To:	Rob Johnston	At:	Scentre Group
From:	Chris Lawlor Tim Sullivan	At:	SLR Consulting Australia Pty Ltd
Date:	28 February 2019	Ref:	620.12132-M03-v1.1 Revised Planning Proposal Transport Review 20190228.docx
Subject:	Westfield Eastgardens Revised Planning Proposal Review of Transport Matters

Westfield Eastgardens Expansion SLR Response to Cardno Modelling Peer Review Comments

Cardno Peer Review Comments

Figure 1 Comparison of Wentworth Avenue/Page Street Intersection Layout

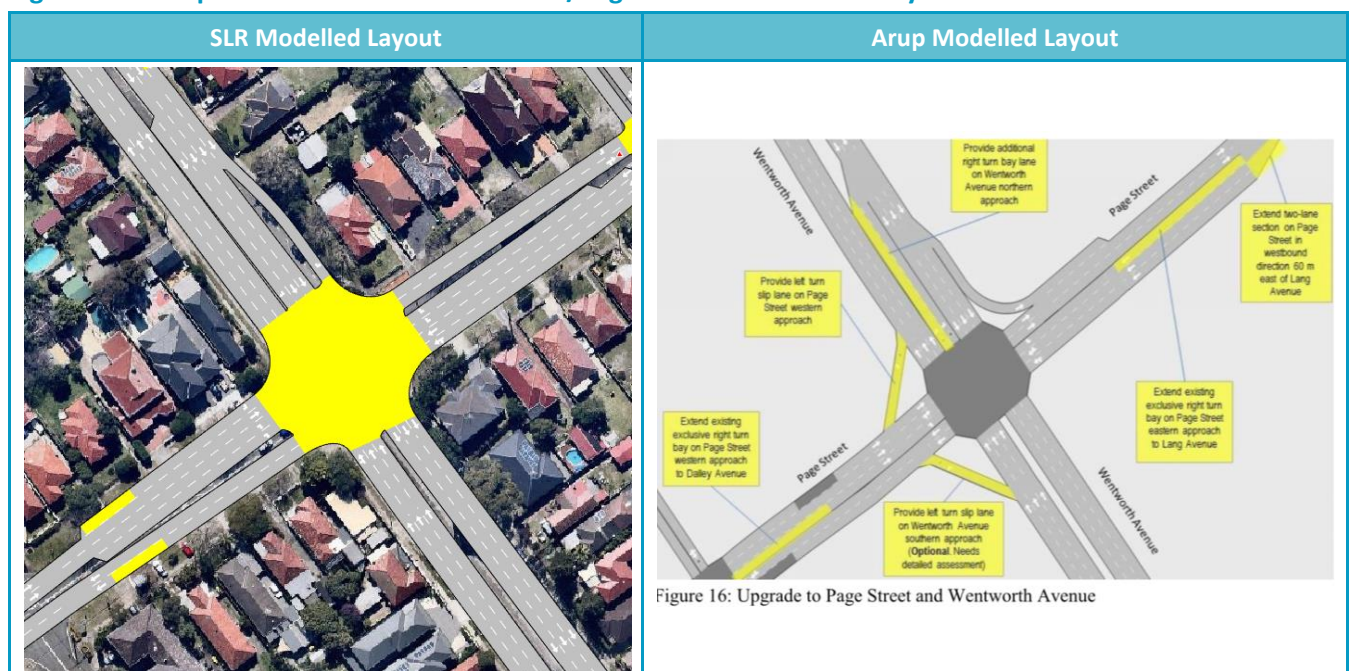
Element	Differences	Commentary on Impacts
External Intersections/Upgrades		
Wentworth Avenue/Page Street intersection	- SLR has modelled a proposed intersection upgrade layout (shown on Figure 1) based on plans provided by Bayside Council; - Arup has modelled an upgraded intersection layout (shown on Figure 1) with additional left turn slip lanes on the south-eastern Wentworth Avenue and south-western Page Street approaches. These slip lanes will result in extensive property impacts.	The SLR modelled intersection layout was shown to provide an adequate Levels of Service (i.e. LOS C or better for all assessed scenarios and peak periods as per Section 4.4 of the SLR Modelling Options report), with sufficient spare capacity to cater for any moderate increases in traffic arising from the updated Meriton and Westfield planning proposals.
Meriton Site Accesses		
Bunnerong Road/Meriton Boulevard	- SLR has modelled a left in/left out/right in signalised intersection (shown on Figure 2) based on previous Arup reporting; - Arup has now modelled a left in/left out only priority intersection at this location (shown on Figure 2).	The impact of removing the signalised intersection from the model is that travel times/delays along Bunnerong Road will improve over that previously modelled by SLR. This improvement in travel time will occur across all scenarios, and will therefore not materially impact on the results previously reported by SLR. In consideration of the conservative traffic demand assumptions adopted by SLR, the impact of this change is expected to be minimal. At a high level, the removal of the right turn movement into Meriton Boulevard from Bunnerong Road will likely redistribute a number of trips (i.e. associated with the Meriton development) through the following intersections: 1. Bunnerong Road/Maroubra Road/Heffron Road intersection; 2. Heffron Road/Banks Road intersection. Based on a review of path assignment data from the AIMSUN model, the number of trips anticipated to be redistributed between movements at the above intersection is presented on Figure 3. As detailed in Section 4.4 of the SLR Modelling Options Report, both intersections 1 and 2 are anticipated to operate at a Level of Service of B or higher for all assessed scenarios and peak periods, and hence the redistributed Meriton traffic demands will readily be accommodated by the remaining capacity of each intersection. On this basis, no additional modelling is considered to be warranted.

Figure 3-1 Mismatch of Section Altitudes at Node 2801

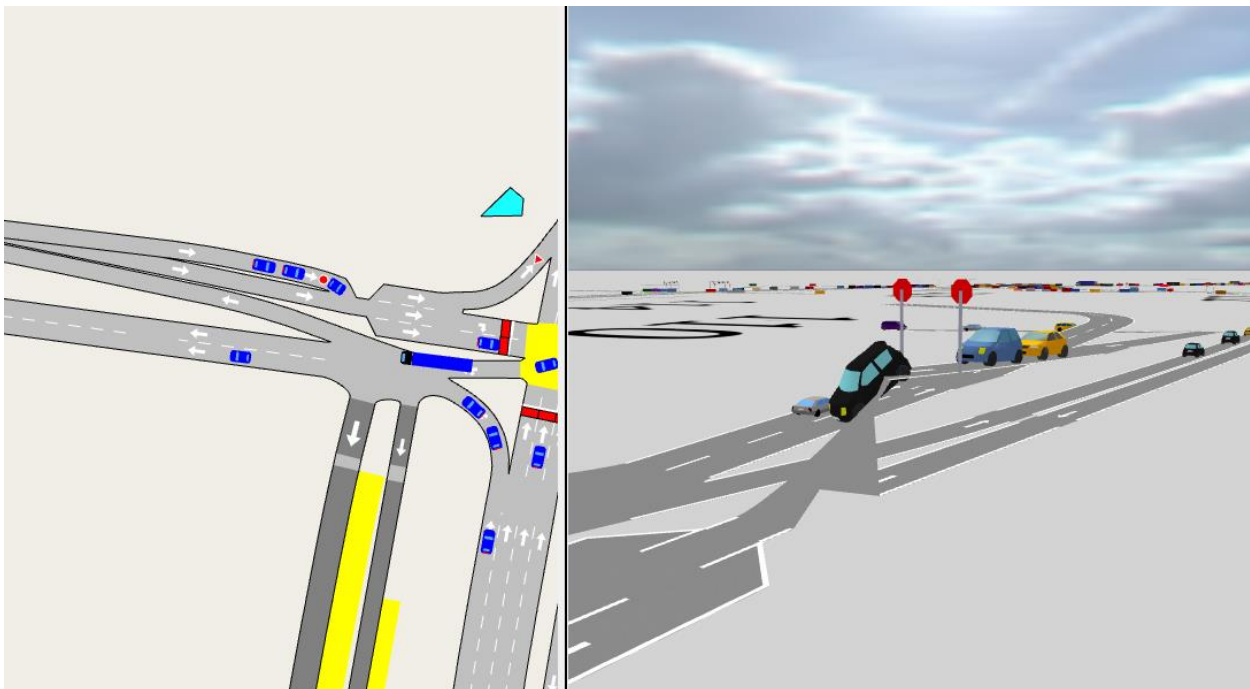
Section altitudes do not match at node 2801, thus creating a 5.7m “drop” at the node as shown in **Figure 3-2**. This mismatch is considered to be minor and is likely to be rectified for further analysis if the application is to proceed post Gateway.

3.1.3 Node 2801 – Altitude Mismatch	Section altitudes do not match at node 2801, thus creating a 5.7m “drop” at the node as shown in Figure 32. This mismatch is considered to be minor and is likely to be rectified for further analysis if the application is to proceed post Gateway.	This error has been corrected in all model scenarios. All scenarios have been rerun and the updated results are presented in the amended Modelling Options Assessment report.

Figure 3-2 Virtual Queue for Section 1277 for 2031 TPM Base + Meriton + Westfield Scenario

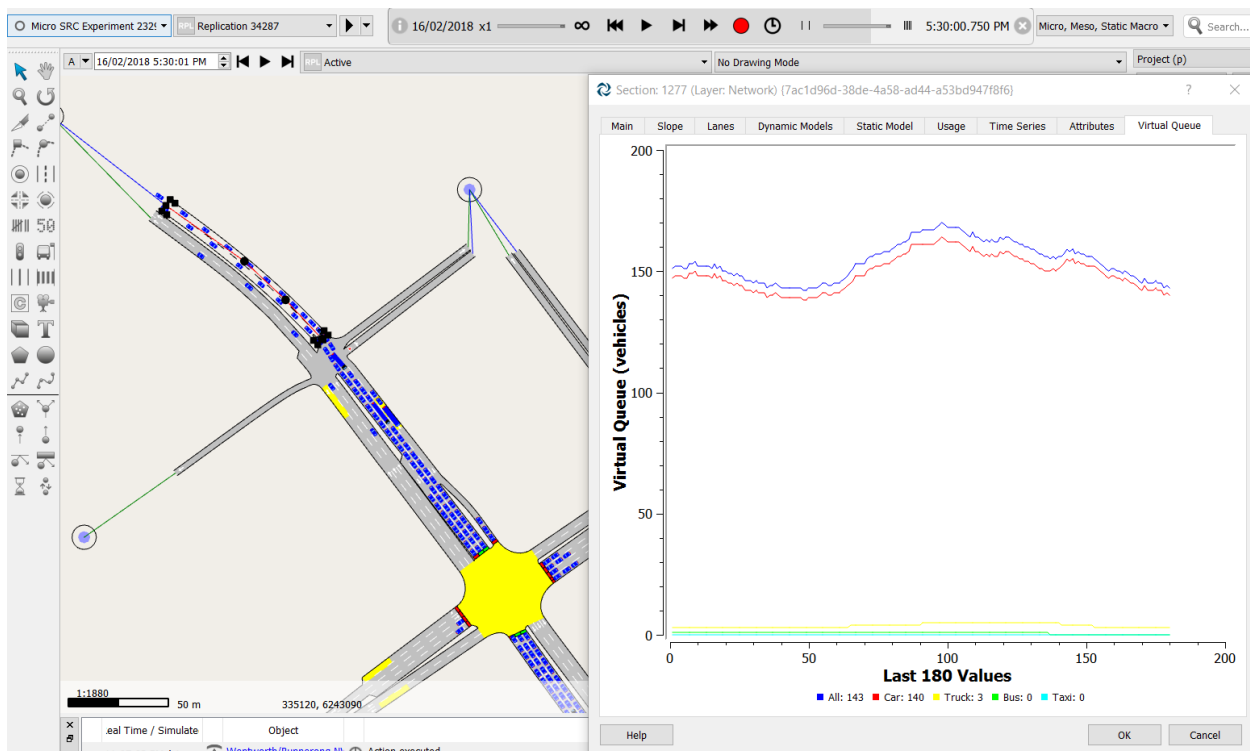
At the end of the main simulation period for the 2031 TPM Base + Meriton + Westfield scenario (i.e. at 5:30) there is a virtual queue of approximately 150 vehicles on Section 1277 (refer **Figure 3-2**), which would not have been accounted for in the reported delays. This is only observed to occur in the TPM scenario, not the SAT scenario.

3.1.4 Virtual Queues on Section 1277 at End of Peak Hour	At the end of the main simulation period for the 2031 TPM Base + Meriton + Westfield scenario (i.e. at 5:30) there is a virtual queue of approximately 150 vehicles on Section 1277 (refer Figure 3-2), which would not have been accounted for in the reported delays. This is only observed to occur in the TPM scenario, not the SAT scenario.	At the same point (i.e. 5:30PM) in the '2031 TPM Base + Meriton' scenario, there is a virtual queue of 150 vehicles on Section 1277. Furthermore, there is a virtual queue of around 100 vehicles present in the '2031 TPM Base' scenario on Section 1277, and on Section 23311 (Page Street southwestern approach), a virtual queue of around 240 vehicles is present at the end of the peak hour period (this is due to the constrained existing intersection form, which is upgraded in the '+ Meriton' scenario). Based on the above, the virtual queue issues are present across <u>all scenarios</u> at the Wentworth Avenue/Page Street intersection, and hence the reported delays are considered to show the relative incremental impact of each model scenario, and are not biased in favour of the Westfield development. Accordingly, no further action is considered to be warranted.

Figure 3-5 Modelled Travel Time Statistics for Route 1 Eastbound the 2031 Base TPM + Meriton + Westfield scenario

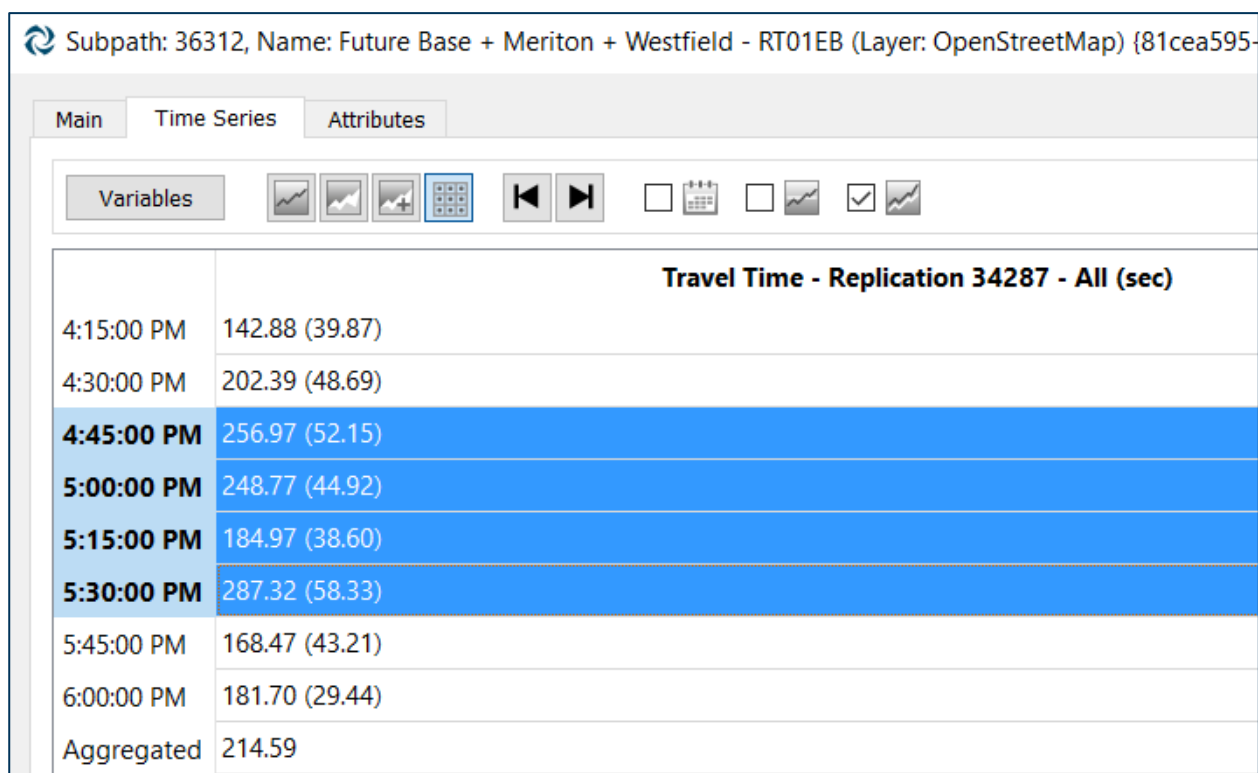
Spot checks confirm that the reported results in Table 17 and 18 can be replicated in the supplied models. However, as shown in it appears that the reported travel times include both the warm-up and cool-down periods where there is less demand in the network. If these time periods are excluded, the model travel times will likely differ. Example provided in **Figure 3-5** for Route 1 Eastbound the 2031 Base TPM + Meriton + Westfield scenario where the reported travel time is 215 sec. However, is the warm-up and cool-down periods are excluded, the modelled travel time increases to approximately 245 sec.

Section Reference	Cardno Comment	SLR Response
3.1.9 External Travel Route Travel Times	Spot checks confirm that the reported results in Table 17 and 18 can be replicated in the supplied models. However, as shown in it appears that the reported travel times include both the warm-up and cool-down periods where there is less demand in the network. If these time periods are excluded, the model travel times will likely differ. Example provided in Figure 3-5 for Route 1 Eastbound the 2031 Base TPM + Meriton + Westfield scenario where the reported travel time is 215 sec. However, is the warm-up and cool-down periods are excluded, the modelled travel time increases to approximately 245 sec.	The travel time observations collected by others and agreed for use with the City and Cardno are for a 2 hour period across all scenarios, hence the results presented demonstrate the relative travel time impacts of each scenario. Nevertheless, the travel times have been revised to reflect the peak hour period only and are presented in the amended Modelling Options Assessment report. It is important to note that this has not materially altered the findings or conclusions of the prior report and that no changes to the previously recommended engineering upgrades are warranted.
